**NOTICE OF PUBLIC REVIEW AND INTENT TO ADOPT  
A PROPOSED MITIGATED NEGATIVE DECLARATION (Revised)**

County File No. CDS20-09531

**PROJECT NAME:** Grayson Road 10-Lot Subdivision (County File #CDS20-09531)

CREEK STRUCTURE SETBACK EXHIBIT

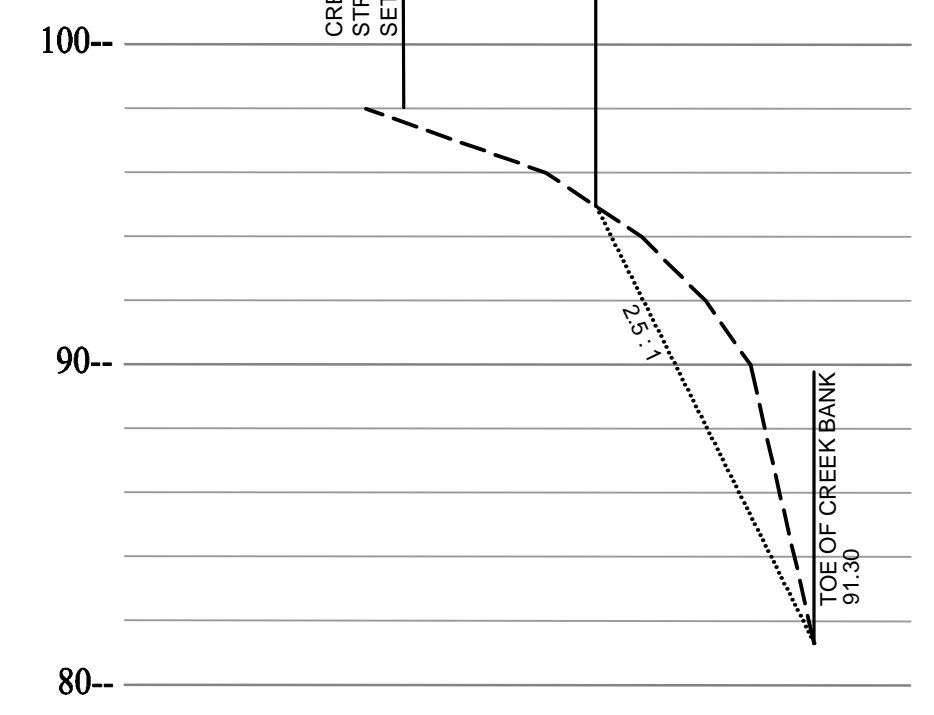
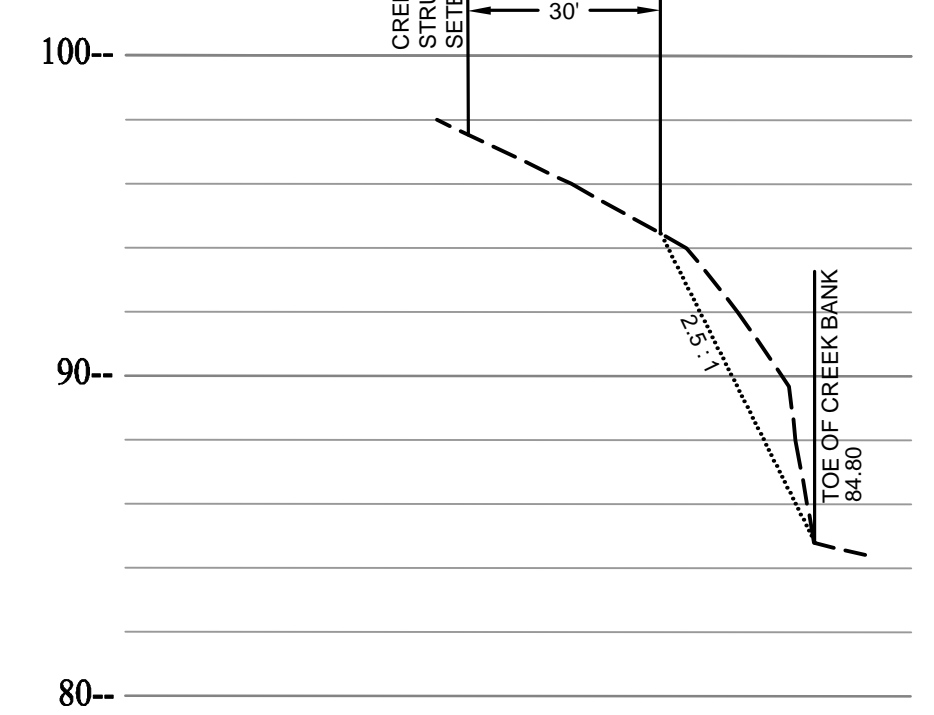
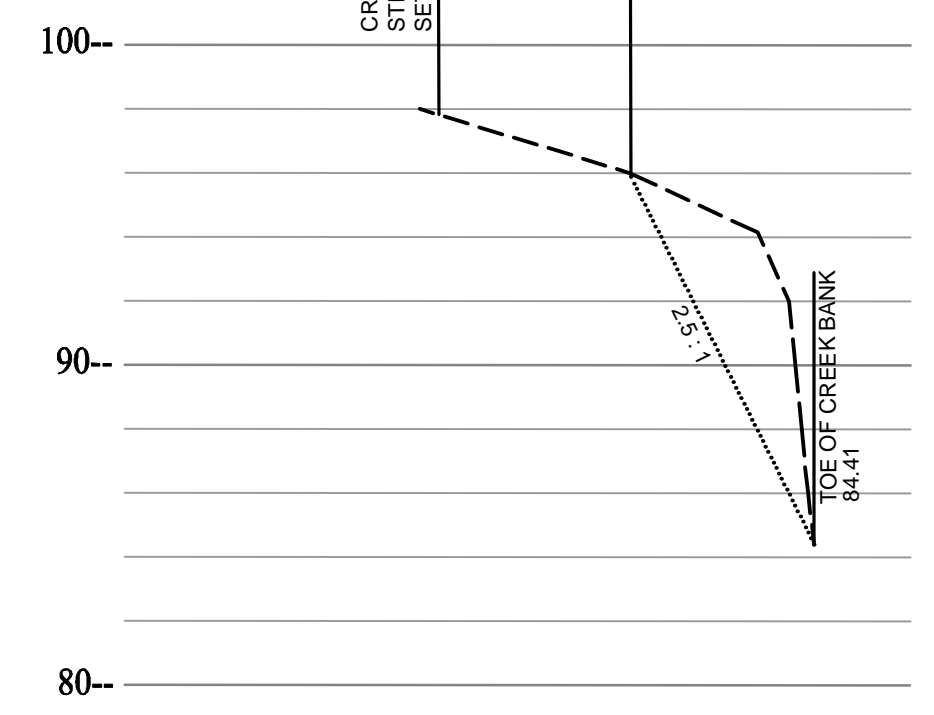
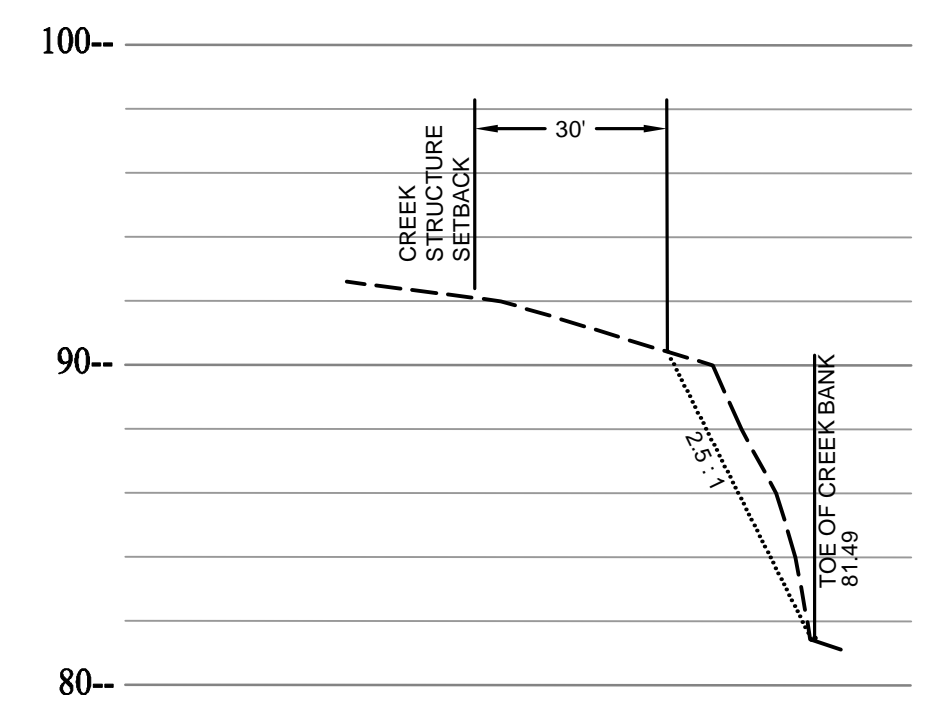
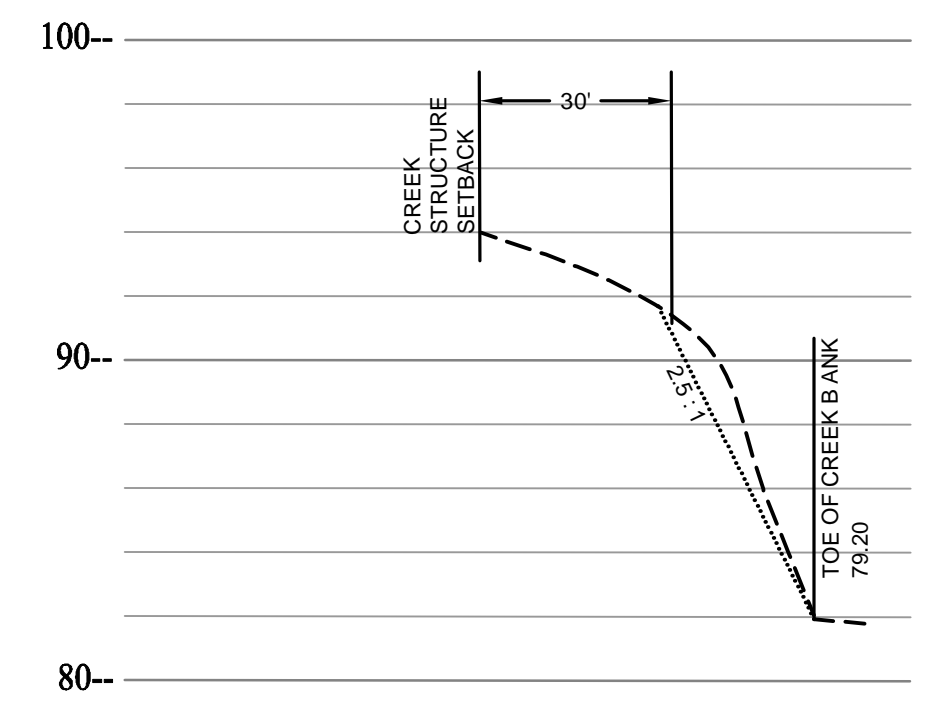
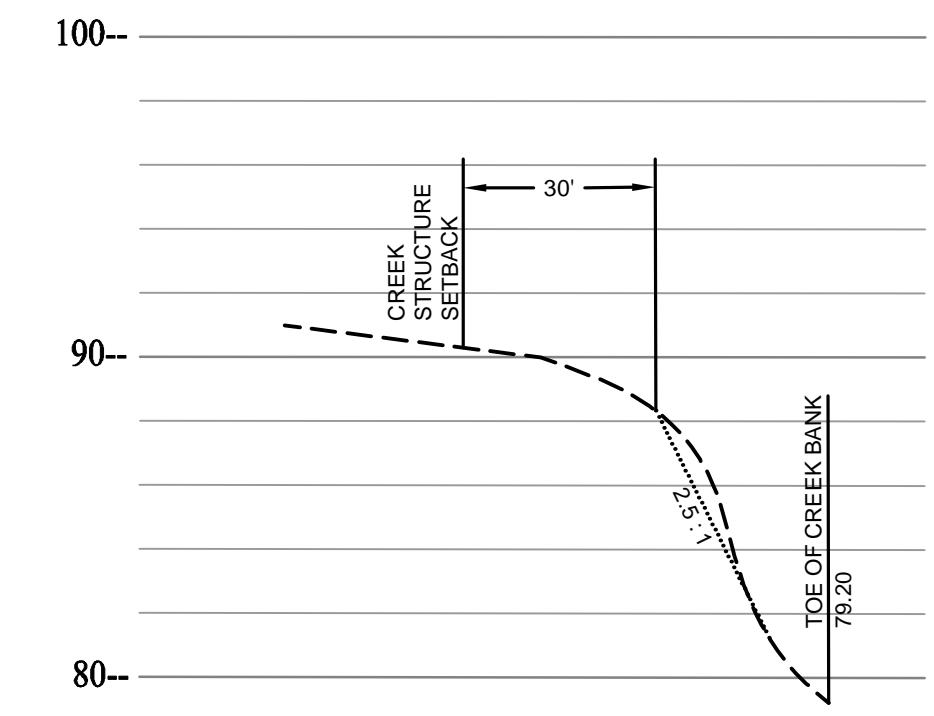
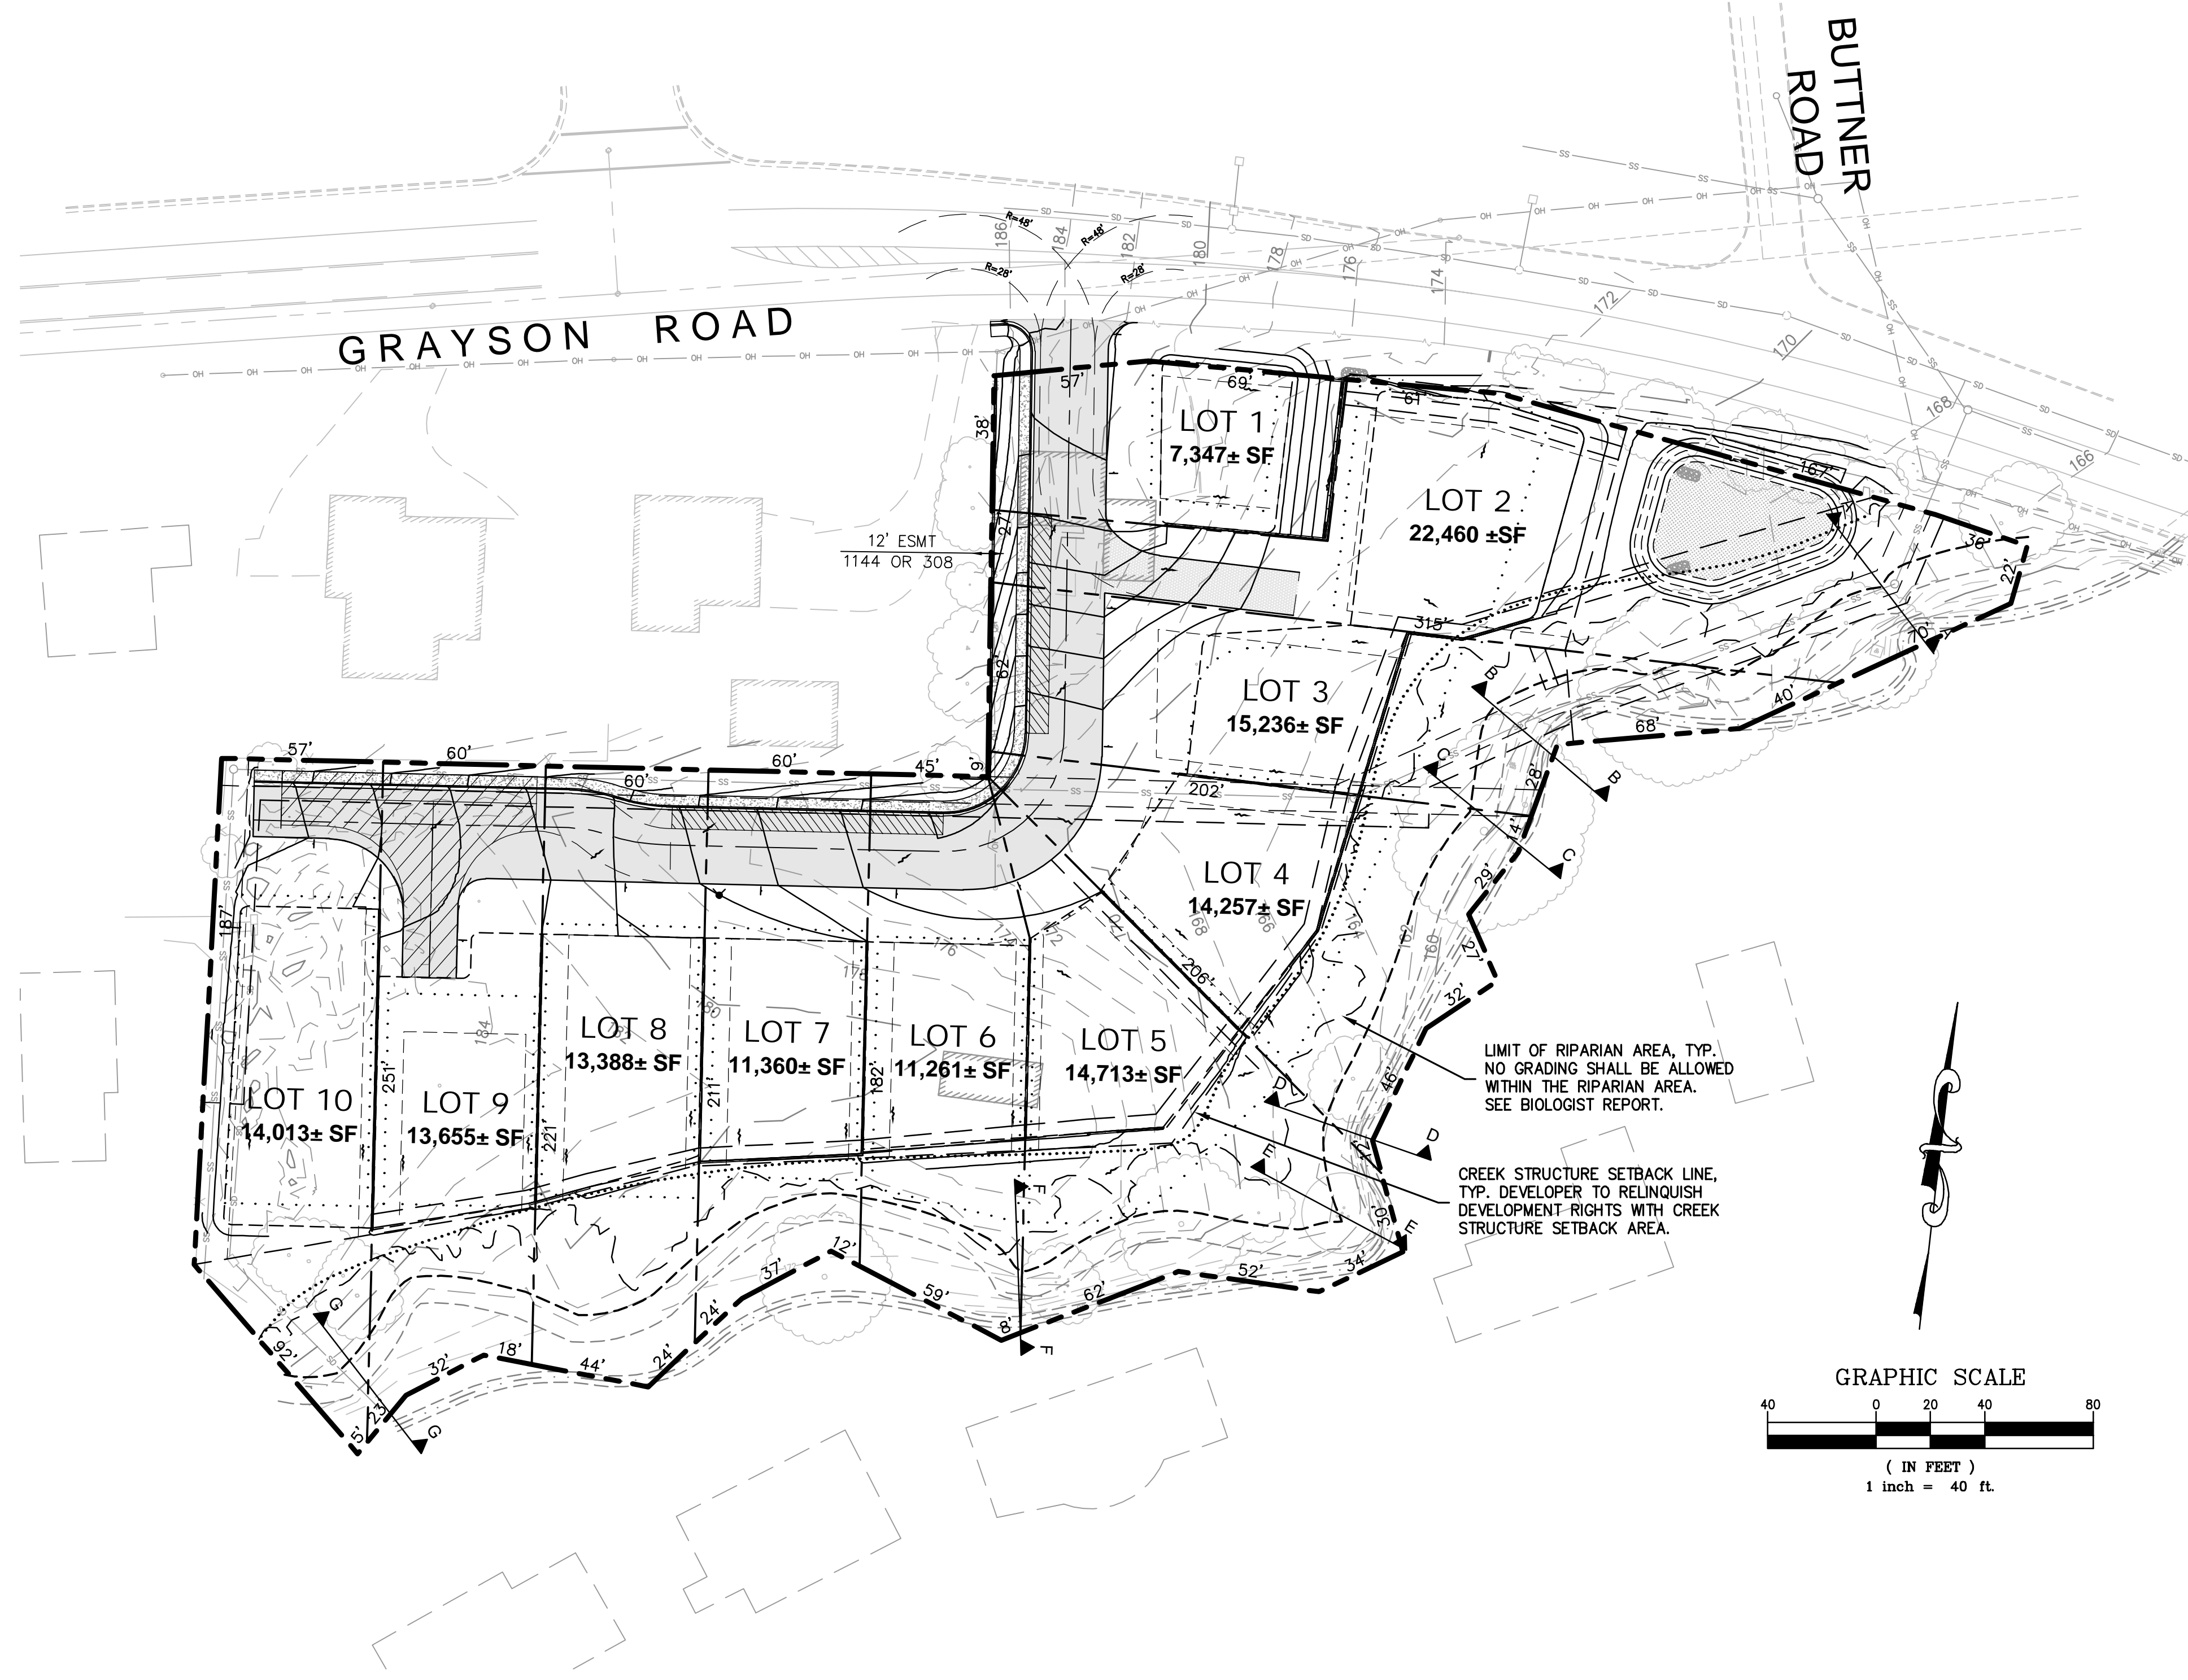
Sheet 4 of the development plans provides some information as to how the creek structure setback was calculated. It appears that only one cross-section was provided at the east end of Grayson Creek with six cross-sections on the westerly end. There are no cross-sections in the middle of this stretch of creek. What was the basis for the location of the cross-sections? How was the number and location of cross-sections determined to be adequate for the establishment of the structure setback lines? How was it determined that the entire creek section is adequately represented by these cross-sections?

Sheet 4 of the development plans provides some information as to how the creek structure setback was calculated. It appears that only one cross-section was provided at the east end of Grayson Creek with six cross-sections on the westerly end. There are no cross-sections in the middle of this stretch of creek. What was the basis for the location of the cross-sections? How was the number and location of cross-sections determined to be adequate for the establishment of the structure setback lines? How was it determined that the entire creek section is adequately represented by these cross-sections?

The commenter states that Sheet 4 of the development plans provides information as to how the creek structure setback was calculated, and question the basis for the location of the cross-sections, how the number and location of cross-sections was determined to be adequate for the establishment of the structure setback lines, and how it was determined that the entire creek section is adequately represented by these cross-sections.
